CHATSWOOD TO SYDENHAM
**SYDENHAM STATION
AND SYDNEY METRO
TRAINS FACILITY SOUTH
MODIFICATION
SUBMISSIONS REPORT**

Purpose of this report

During public exhibition of the modification report, 15 submissions were received by the Department of Planning and Environment. The Secretary of Department of Planning and Environment provided copies of the submissions to Transport for NSW.

Figure 4 One per cent AEP plus 10 per cent velocity change with modification

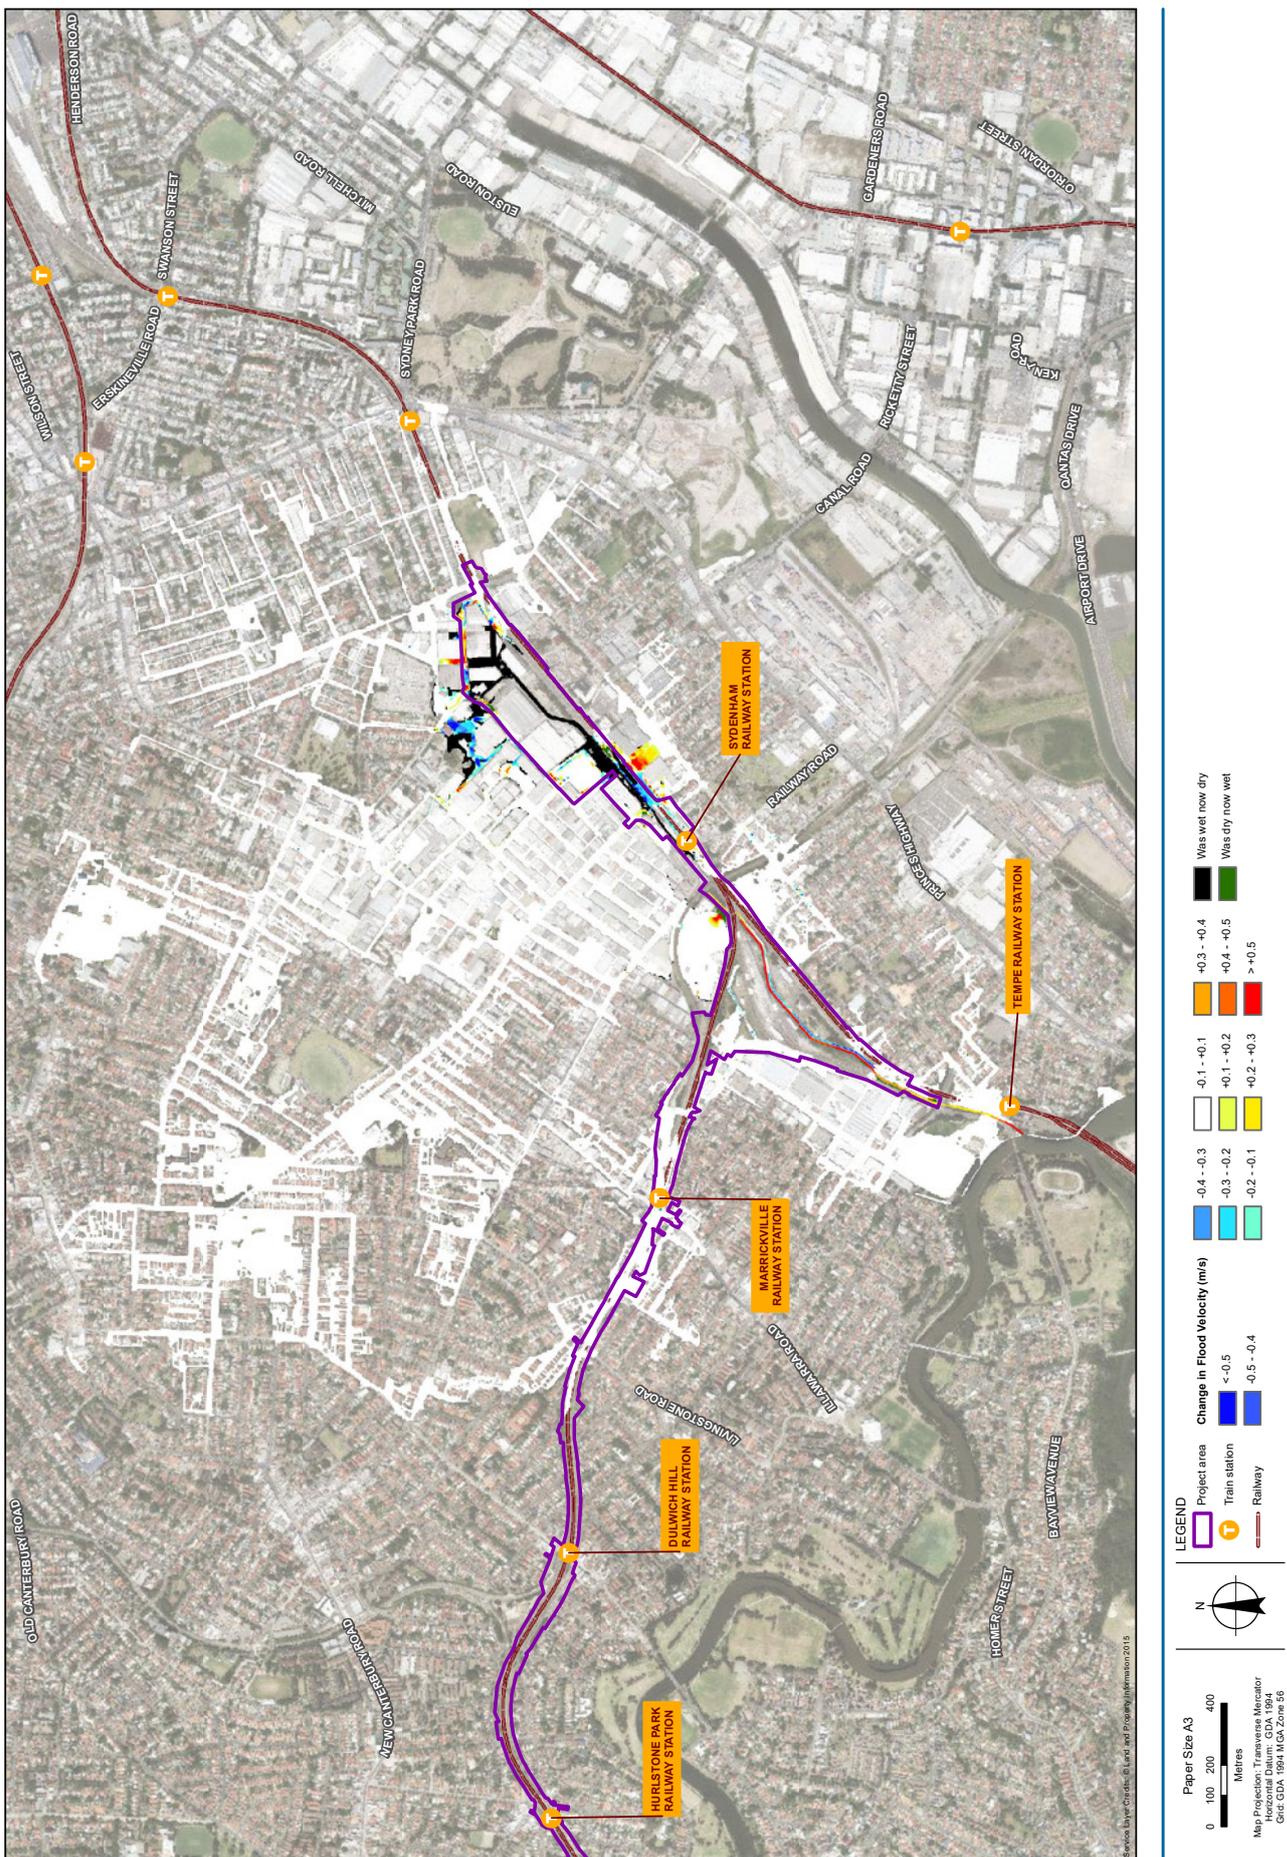
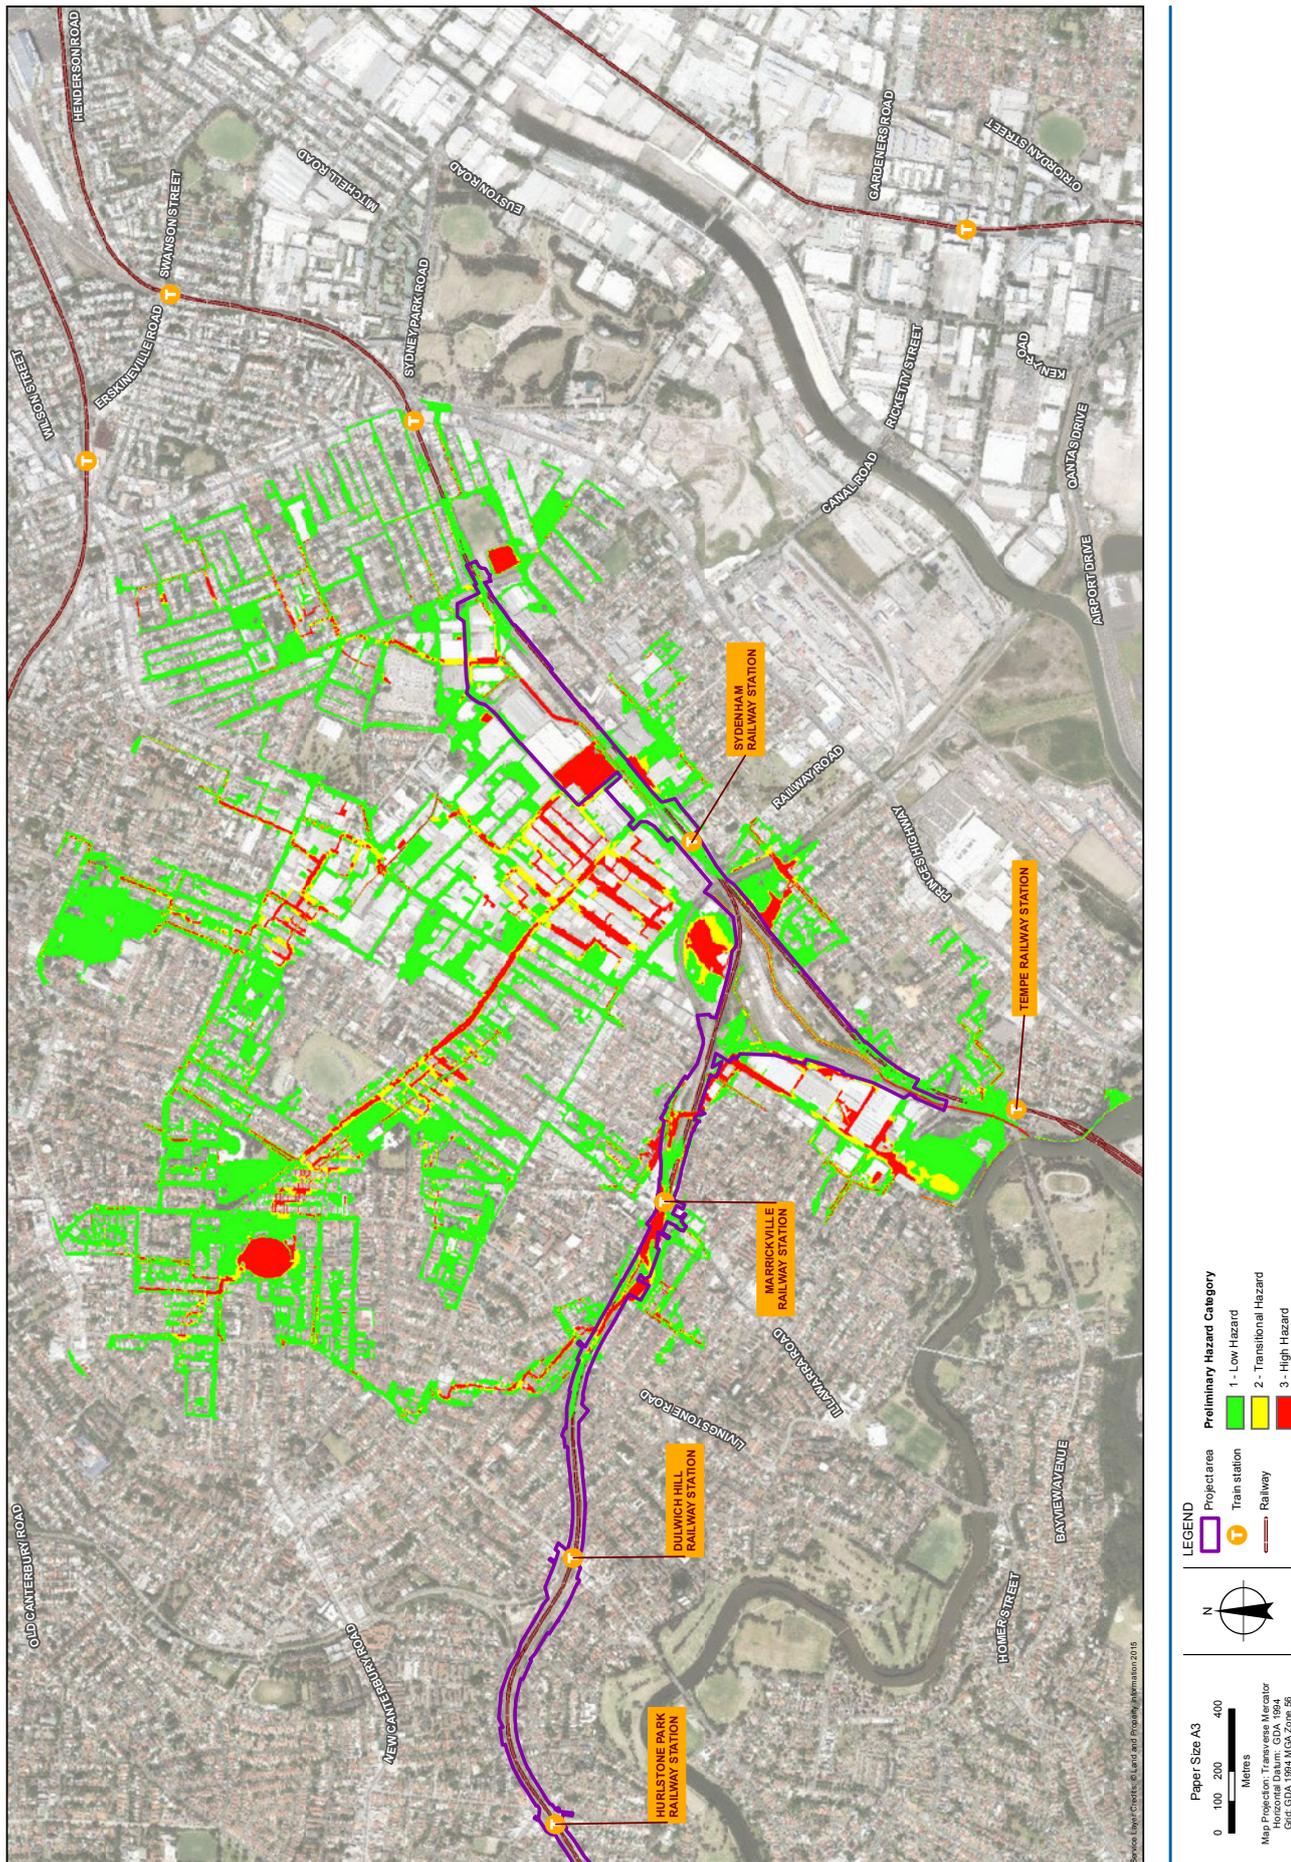
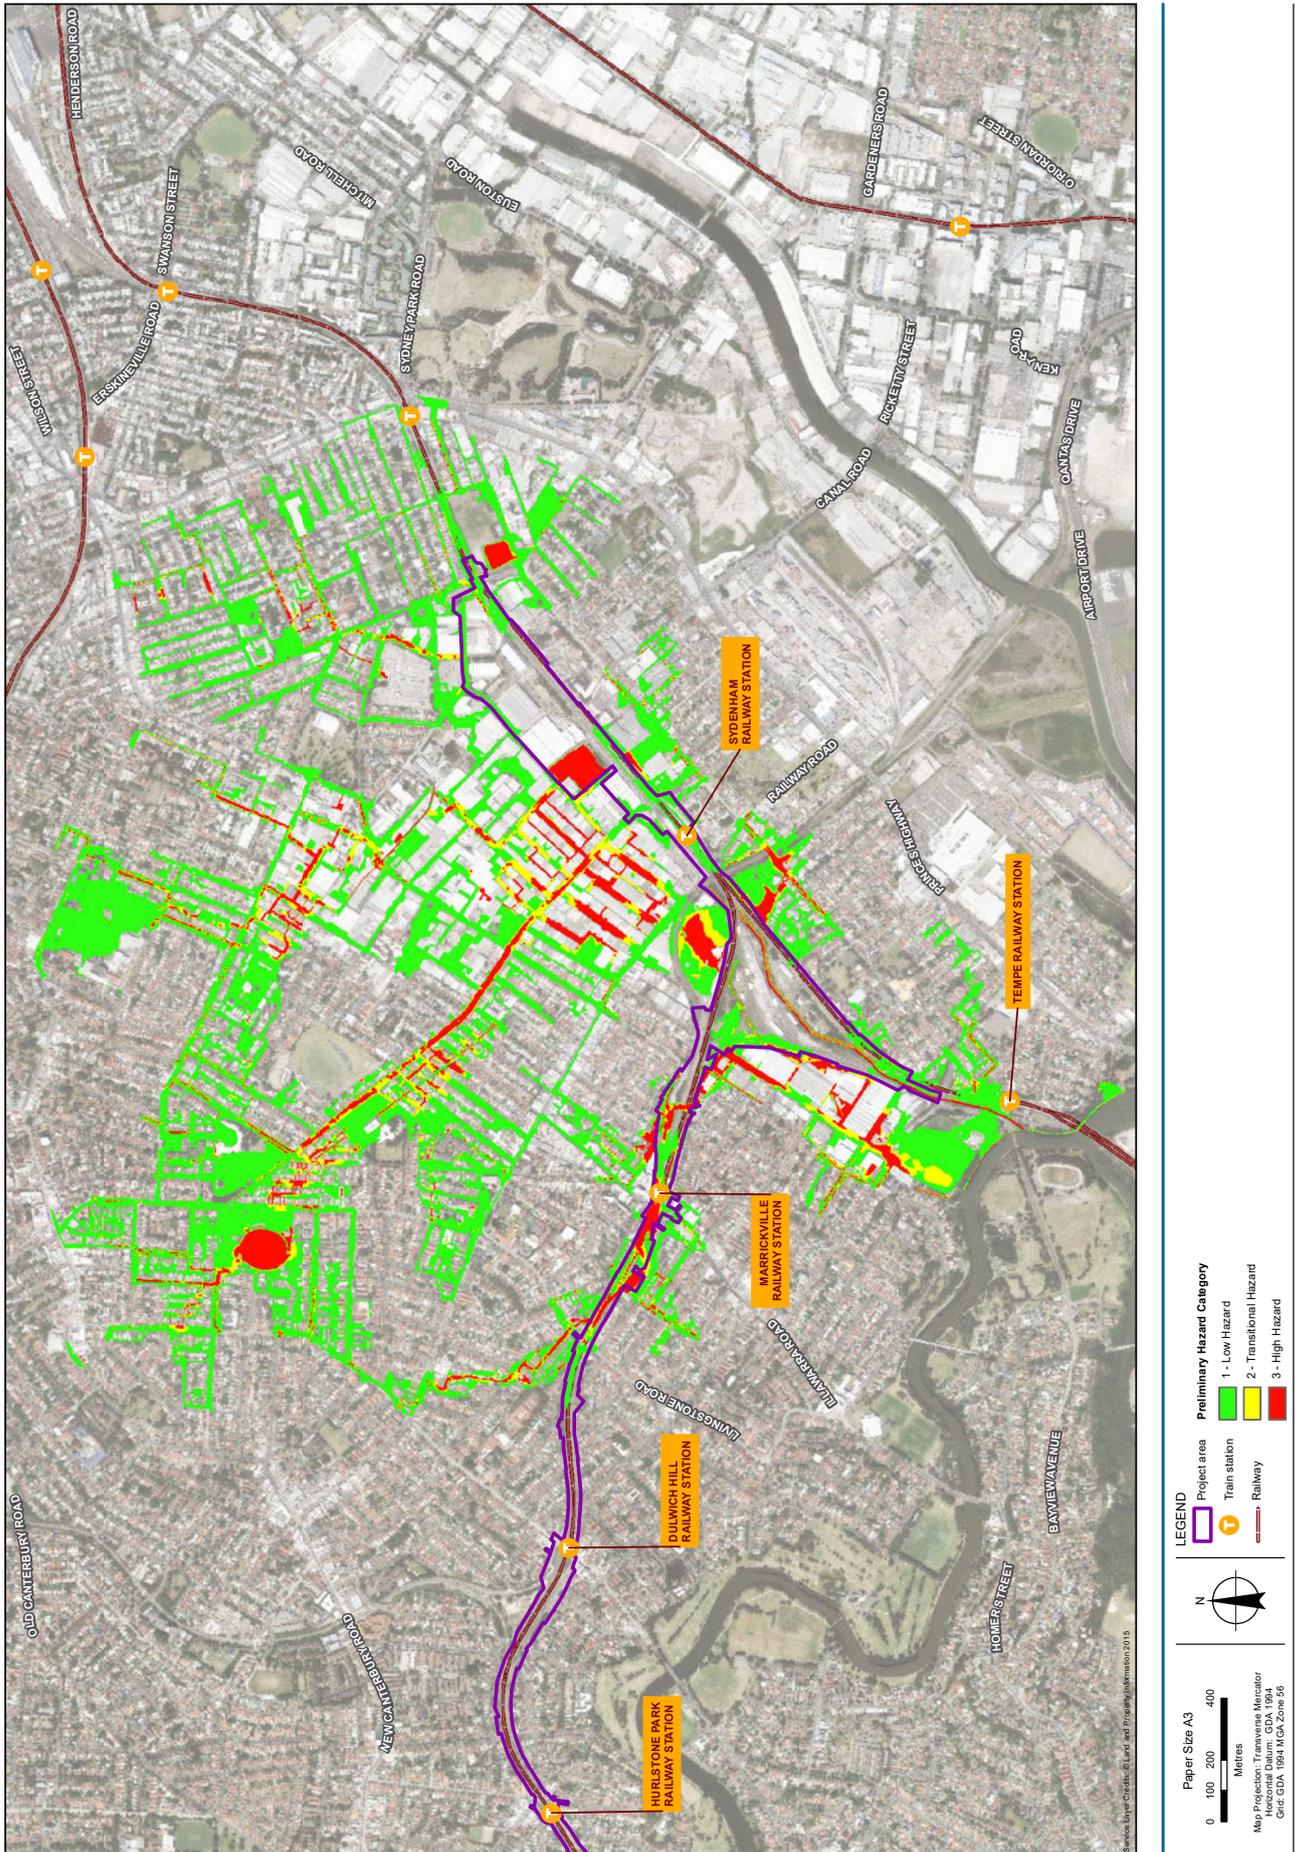
The modification report indicates that the modification will result in increases in flood depth and extent in the vicinity of Frederick and Sutherland streets. From a floodplain risk management perspective, it is prudent that the proponent adequately investigates the following:

- Identify additional properties that would be affected by over floor flooding in 1 per cent annual exceedance probability, which in existing conditions are subject to ground flooding only
- Identify additional properties that would be within the flood planning area, which are currently above the flood planning level
- Identify additional properties that would become flood affected due to the increase in the probable maximum flood extent
- Identify the potential for increase in flood damage due to the above points
- Address impacts on emergency management planning
- Undertake a consultation process with affected property owners and Inner West Council.

The modification report identifies that, with the proposed drainage and flood improvements in place, flooding impacts with the proposed modification would generally be less than those identified for the approved project. Notwithstanding, there is predicted to be an increase in flood depths in some locations, including on Sutherland and Fredrick streets. Additional technical information relating to the flooding assessment is provided in Appendix C.

- The one per cent AEP plus 10 per cent flood level change
- The one per cent AEP plus 10 per cent velocity change
- The one per cent AEP plus 10 per cent provisional flood hazard
- The PMF flood level change (as was provided in the modification report)
- The PMF velocity change
- The PMF provisional flood hazard.

This additional mapping does not change the outcomes of the flooding assessment provided in the modification report. Additionally the mitigation measures, which provide a performance standard for the project, would continue to apply.
